Docket Items #4 & 5  
BAR CASE # 2017-00419 &  
2017-00420

BAR Meeting  
November 29, 2017

**ISSUE:** Permit to Demolish and Certificate of Appropriateness for Alterations

**LOCATION:** 235 Buchanan Street

# ASK 3.2

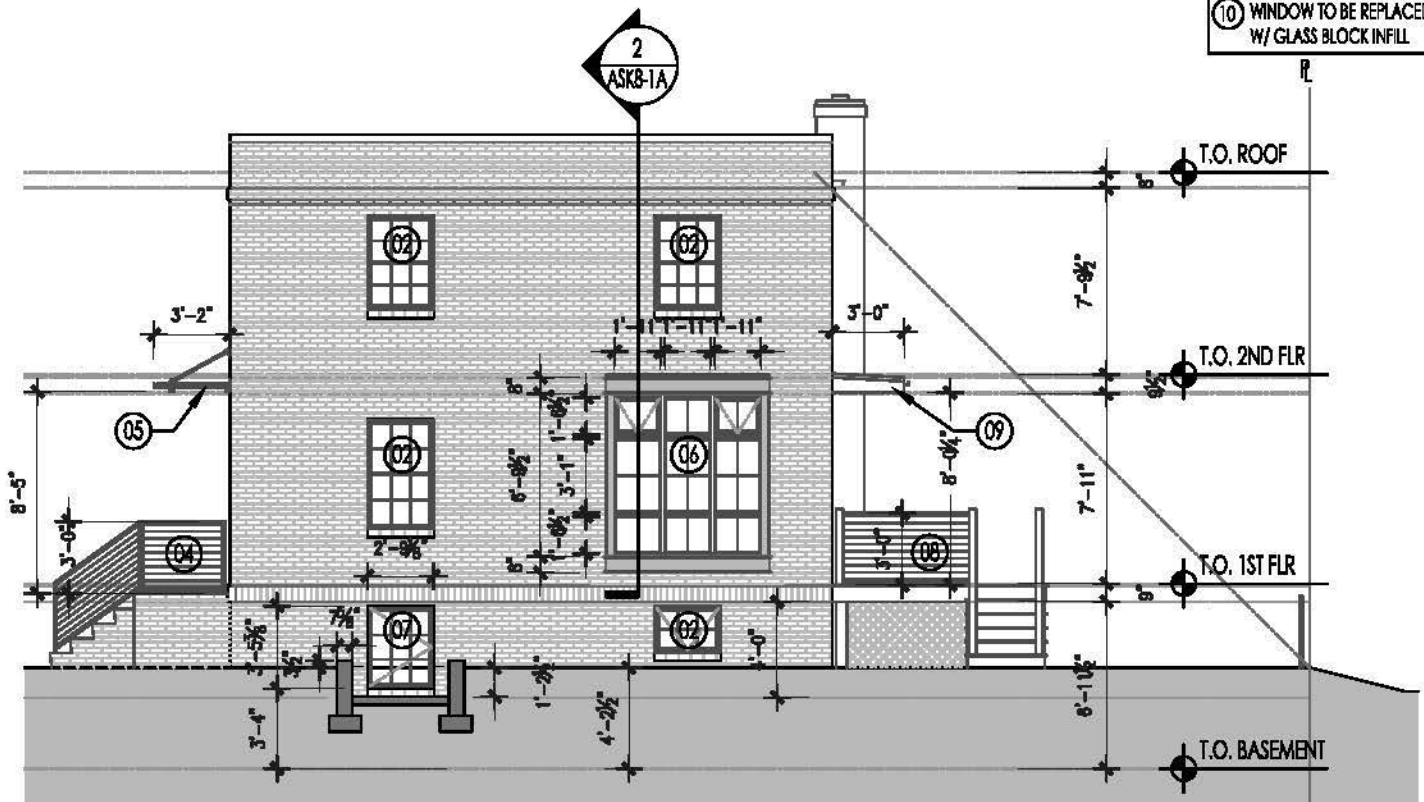
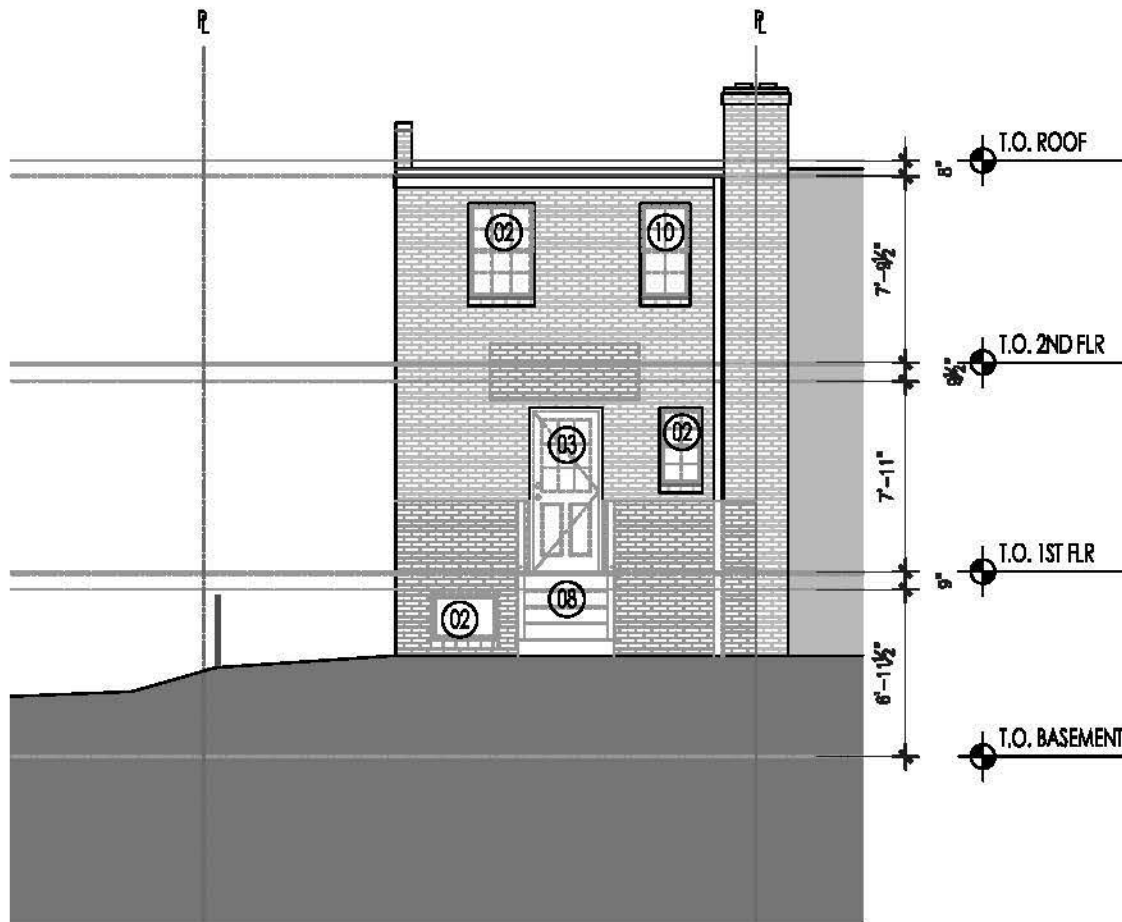
Staff has no objection to the proposed minor demolition (57 square foot) of portions of the south (side) wall of this brick house to accommodate a new bay window opening. Staff finds that there will be no loss of material of such old and unusual or uncommon design, texture and material and that it could be reproduced easily, and recommends approval of the Permit to Demolish.

The applicant proposes a new bay window on the southeast elevation for additional natural light and space. The bay window will be 8'-1 1/2" high, 5' 9" wide, and extend 1'-8". This bay window is visible from Buchanan Street and the public alley. Staff finds the new bay window to be appropriate and compatible with the minimalist Colonial Revival style of the townhouse.

**ASK  
3.3**

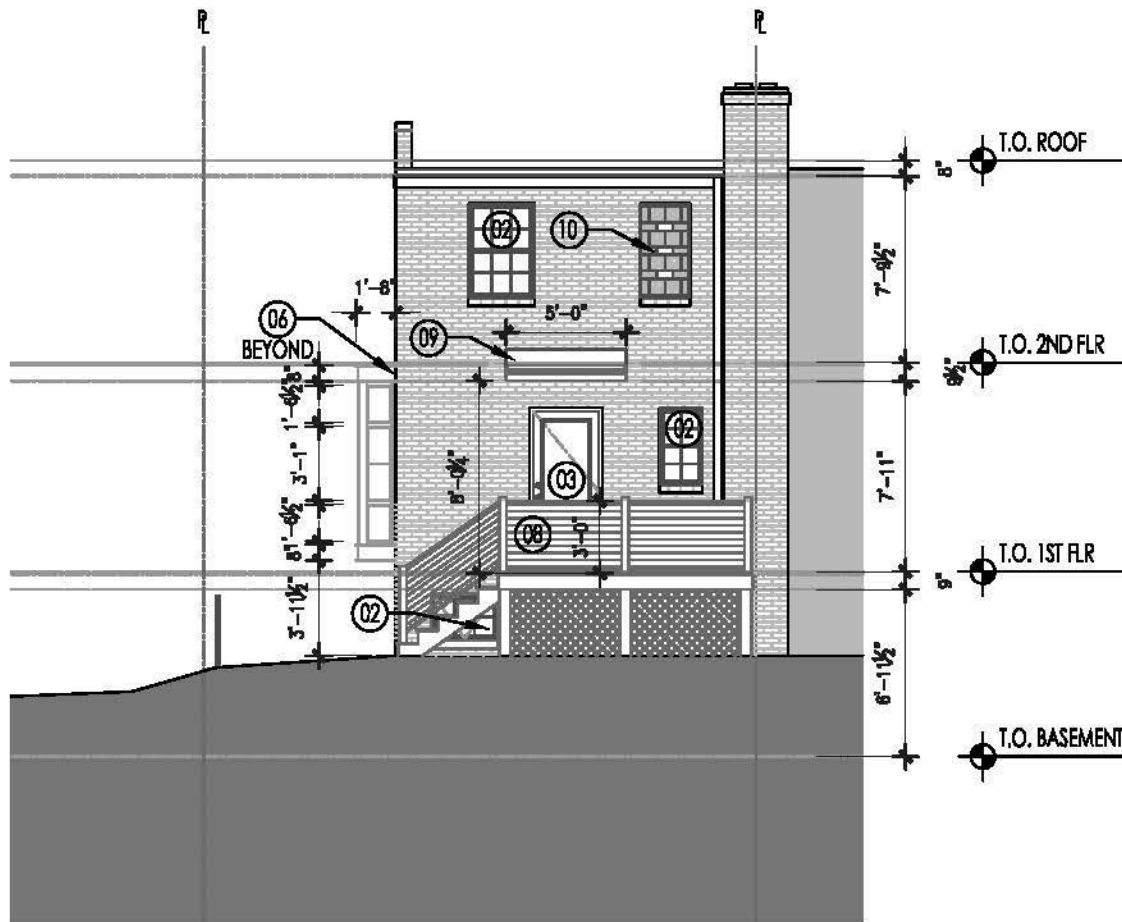
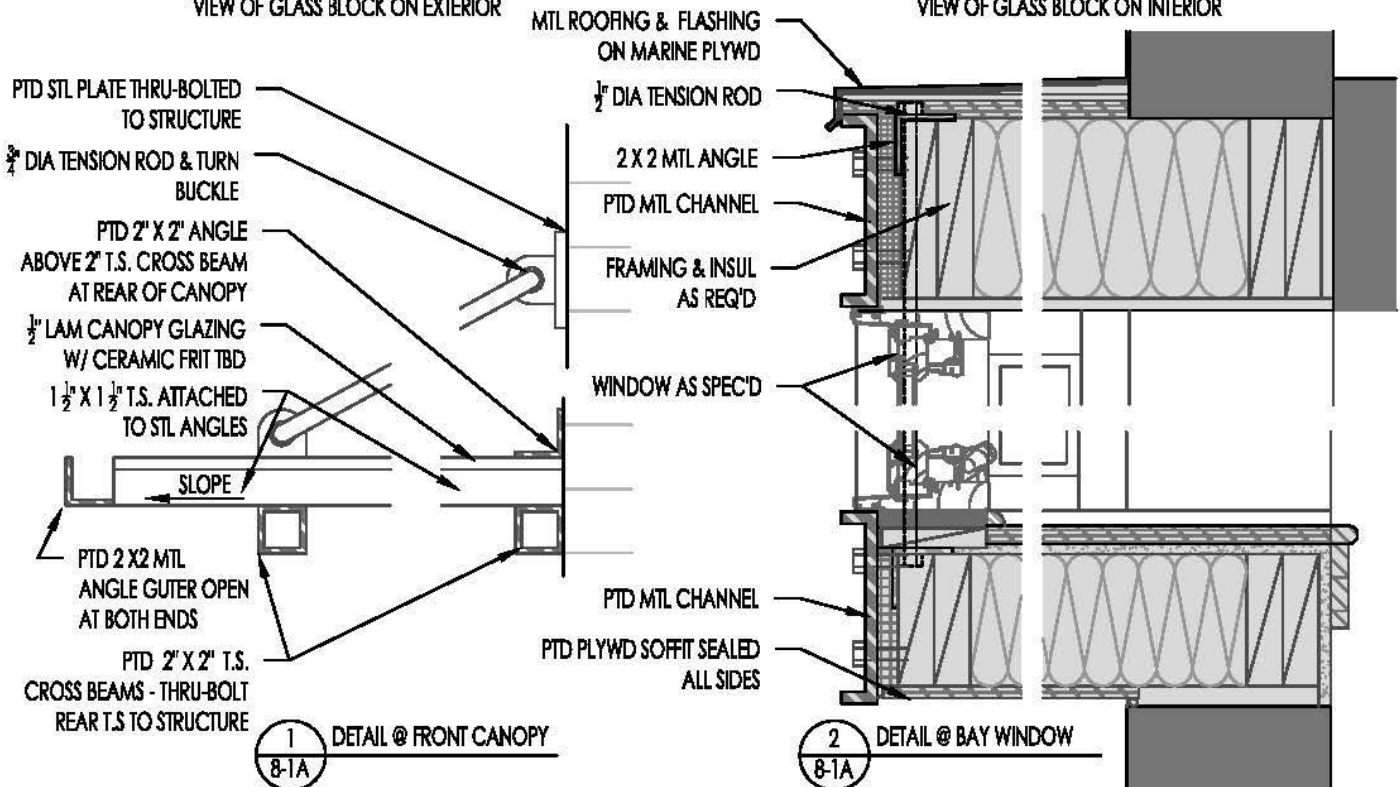
One window on the rear elevation is proposed to be replaced with glass block infill. The infill of this window must go before the BAR because it is located on the second floor. Alterations on the second floor of the rear elevation must be reviewed by the BAR. The window is minimally visible only from the public alley. Staff finds the glass block of the rear window appropriate for this building.
